# AMENDMENT #1

Invitation for Bids (IFB) Number  
PCCD-22-PCW21Rehab-01, 12/9/2021

Issued by  
Plum Creek Conservation District  
Lockhart, Texas

**Amendment No. 1 (1-13-2022)**  
**IFB PCCD-22-PCW21Rehab-01 (Site 21 Rehabilitation)**

SHEET NO.  
2

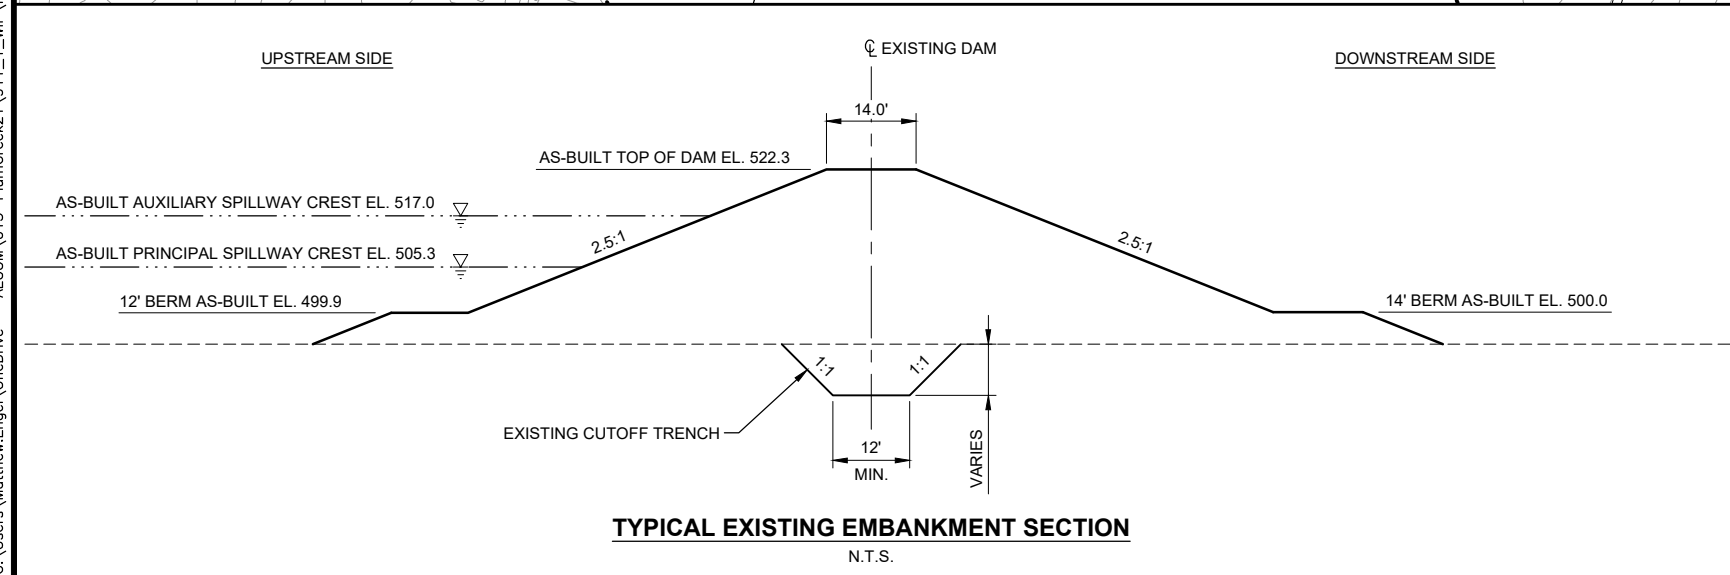
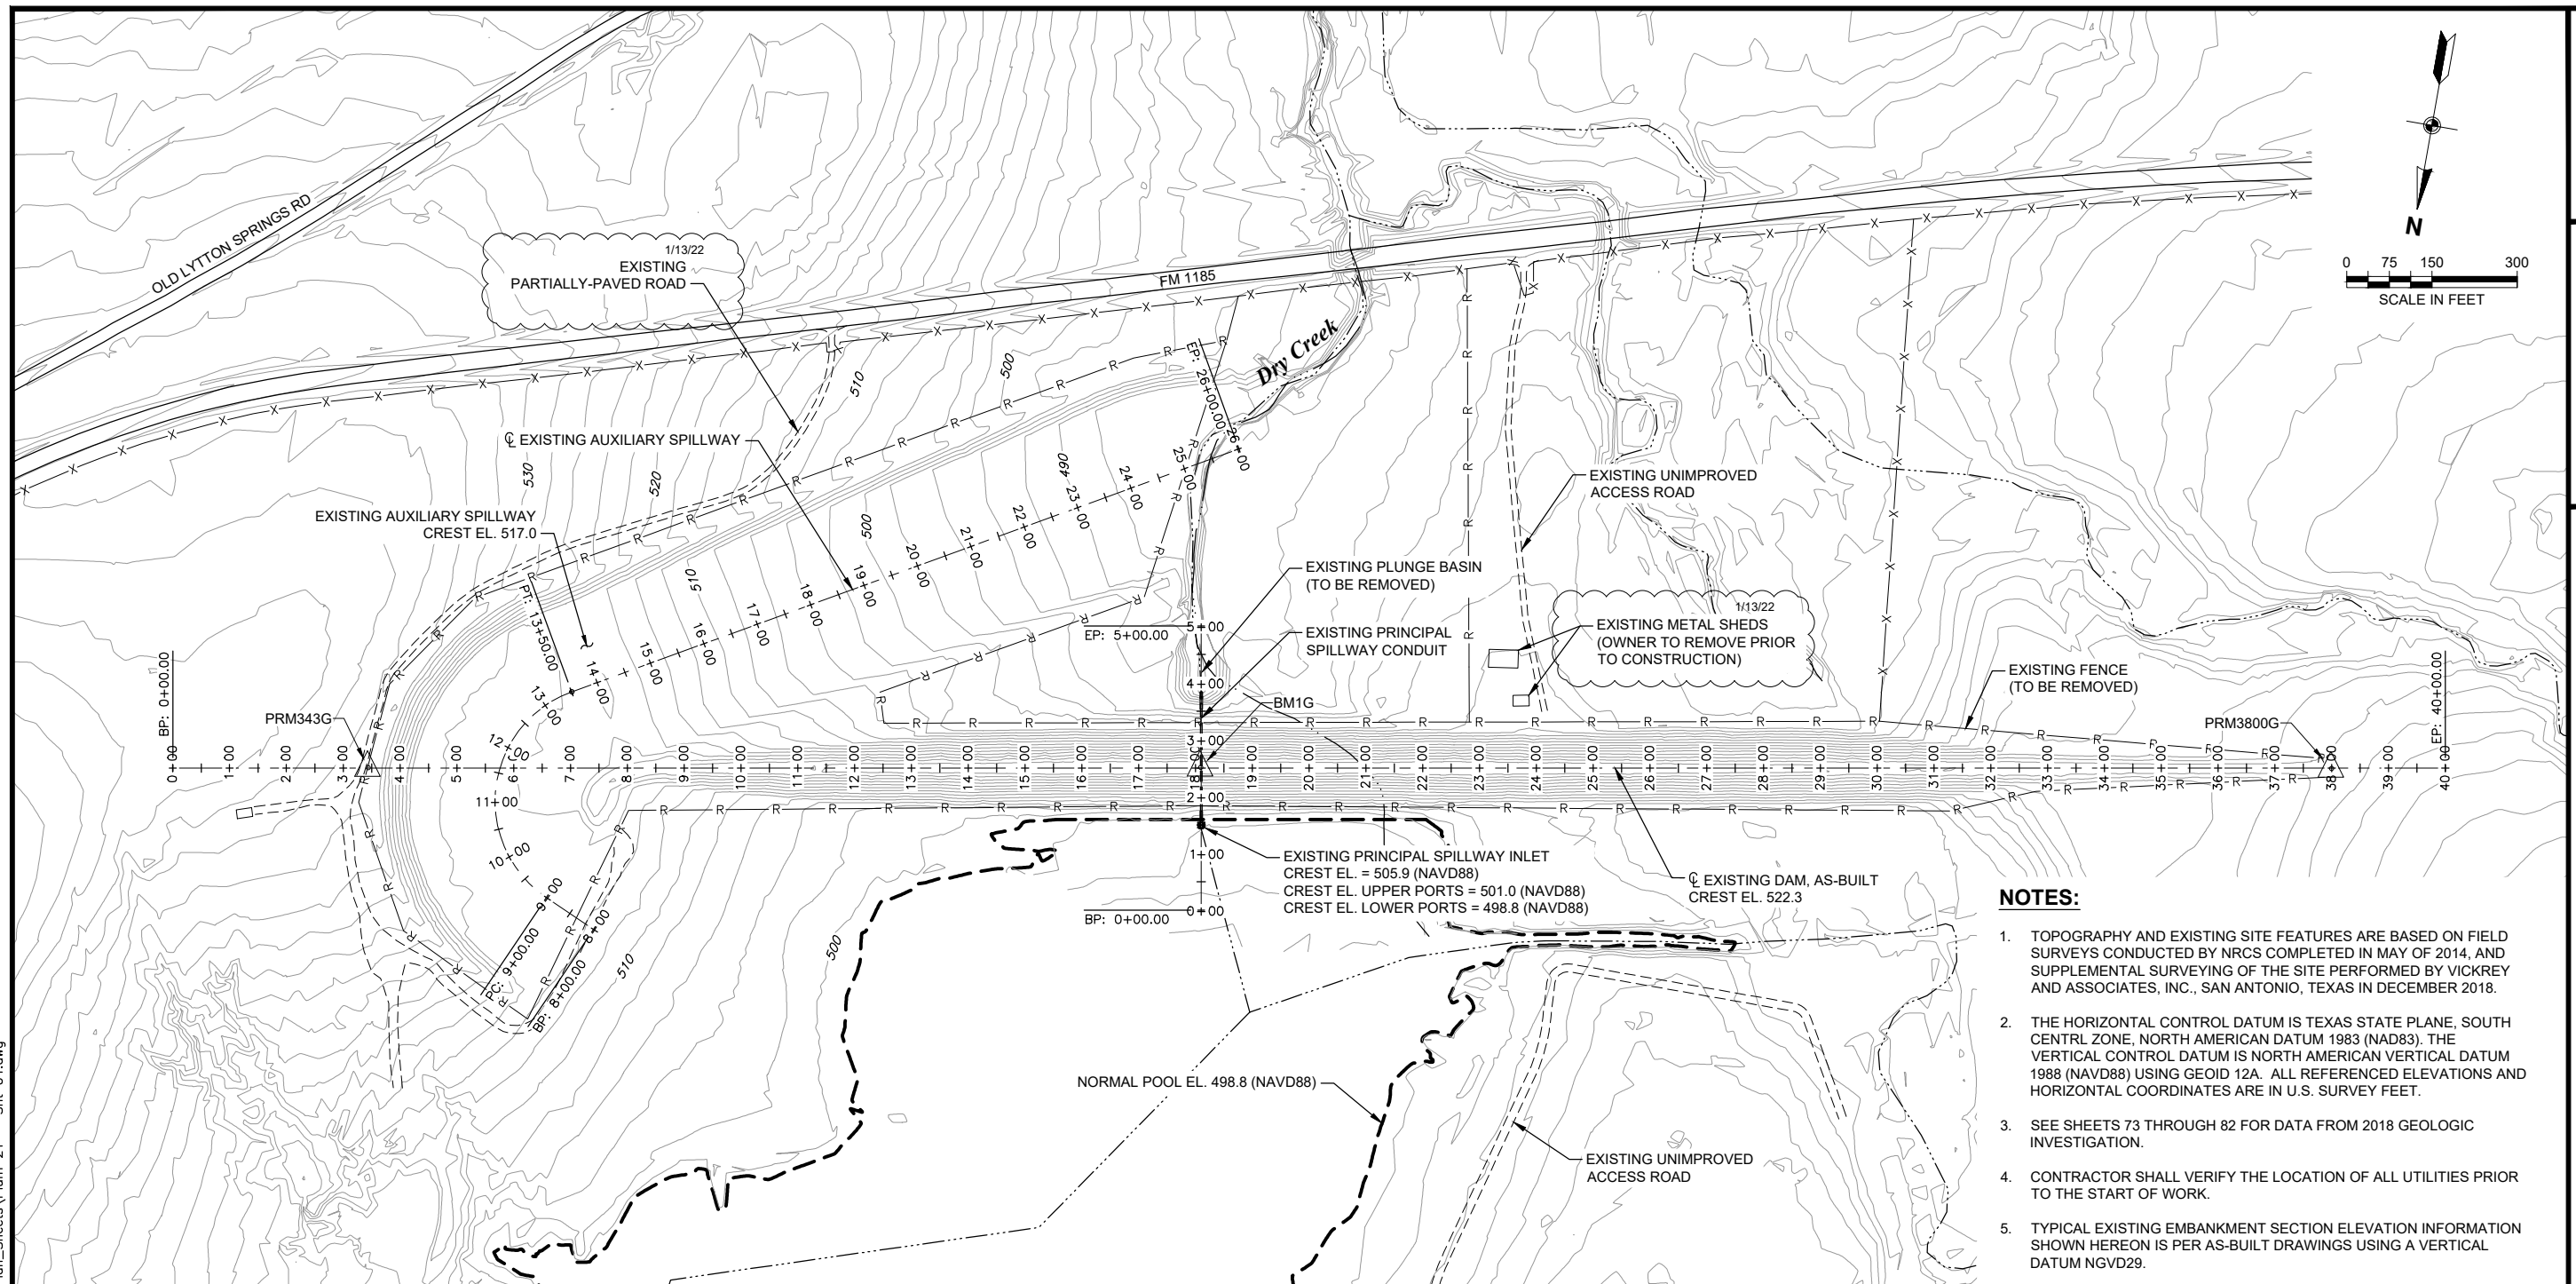
**A:** Yes, see IFB Amendment #1 revised Drawing Sheet 2.

12. NO ON-SITE BATCH PLANT WILL BE PERMITTED FOR PRODUCING STRUCTURAL CONCRETE. AN ON-SITE BATCH PLANT FOR PRODUCING RCC IS REQUIRED PER CONSTRUCTION SPECIFICATION 36. CONTRACTOR IS RESPONSIBLE FOR IDENTIFYING AND OBTAINING ALL NECESSARY PERMITS RELATED TO ESTABLISHING AN ON-SITE BATCH PLANT.

SHEET NO.  
5

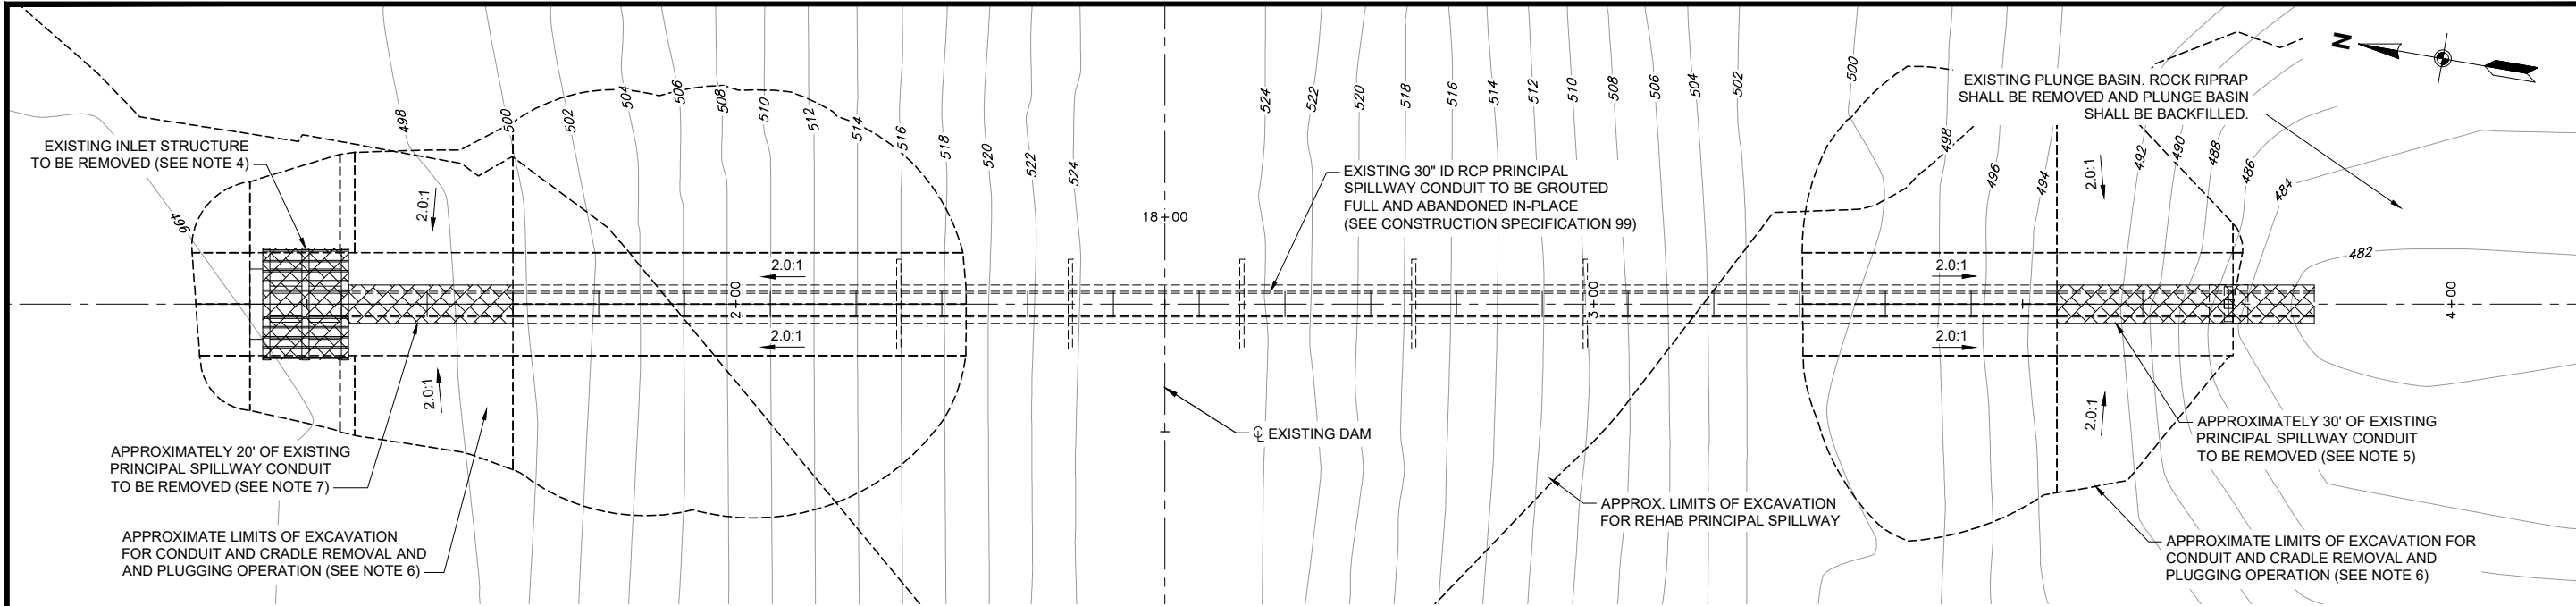
NOTE attached revised Drawing Sheet 5 (sealed 1/13/22) which has moved locations of some items that were on the original drawing. Items that were designated at the time of the site showing:

- Two Access Roads as shown on revised Drawing Sheet 5. Note changes on rev. Sheet 5.
- Two Stabilized Construction Entrances (SCE); one proposed and one alternate.

- Construction Campsite. As shown on revised Drawing Sheet 5 (now designates campsite and alternate campsite locations).
- Stockpile Area and Alternates. Note Alternate Stockpile Area on east end of structure was relocated to the west side of the partially-paved access road.

- Borrow Area 1 and Borrow Area 2 as shown on Drawing Sheet 5.
- Waste Area location as shown on Drawing Sheet 5.
- Buried material locations (will be designated by Engineer during construction)

**Q:** Where is the designated area for the batch plant?

**Q:** Where can the batch plant for the RCC set on site?

**A:** See Sheet 5 (IFB Amendment #1 revision) of the plan drawings.

**A:** See Sheet 5 (IFB Amendment #1 revision) which shows two optional areas.

**A:** See revised Sheet 5 of the drawings sealed 1/13/22 being distributed via IFB Amendment #1.
